Interactive comment on “Calibration of the SBUV version 8.6 ozone data product” by M. T. DeLand et al.

M. T. DeLand et al.

Received and published: 16 October 2012

Fig. 1. Profile ozone differences between Aura MLS and SBUV V8 data (top) and SBUV V8.6 data (bottom).

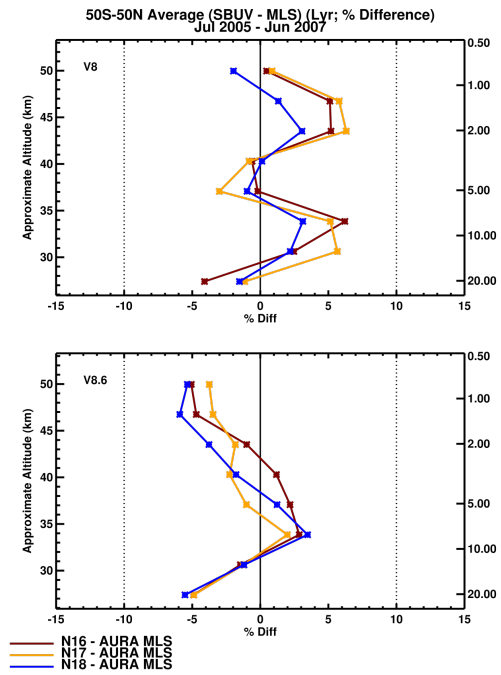
- The main goal of all the calibration procedures applied to the SBUV spectra is to improve the consistency between the ozone profiles retrieved from the different sensors. The procedures themselves are clearly described. But the paper would greatly benefit from an illustration of the impact of these calibrations on the retrieved ozone profiles themselves, where possible. Is it possible to show how improved is the consistency

between the ozone profile data sets from the different instruments as a consequence of some of the calibration procedures?

» While other forthcoming papers from our group address the behavior of the SBUV V8.6 ozone products in extensive detail, we agree that an illustration of the improved data quality in this paper is also useful. We have added Figure 12 in the revised manuscript to compare the agreement between Aura MLS profile ozone data and data from overlapping SBUV/2 instruments (NOAA-16, NOAA-17, NOAA-18), using both our previous Version 8 (V8) product and the new V8.6 product.

Revised Text (p. 5168, after line 15). The improvement in ozone profile data quality produced by the calibration changes discussed in this section is noticeable when examining data from the most recent SBUV instruments on NOAA-16, NOAA-17, and NOAA-18. Figure 12 shows zonal average profile ozone comparisons with Aura MLS Version 3.3 ozone data, using both the previous SBUV V8 data product (top panel) and the current V8.6 data product (bottom panel). The significant decrease in oscillating vertical structure, or “ringing”, for the V8.6 comparisons comes from the channel adjustment procedure used for NOAA-17. The improved agreement between these three SBUV instruments in the V8.6 product comes from the use of the “no local time difference” intercalibration technique.

Caption for Figure 12. Profile ozone differences [in percent] between Aura MLS V3.3 data and SBUV/2 instruments on NOAA-16, NOAA-17, and NOAA-18, using zonal averages between 50°N–50°S for the period July 2005 – June 2007. Comparisons to the SBUV V8 data product are shown in the top panel, and comparisons to the SBUV V8.6 product discussed in this paper are shown in the bottom panel.
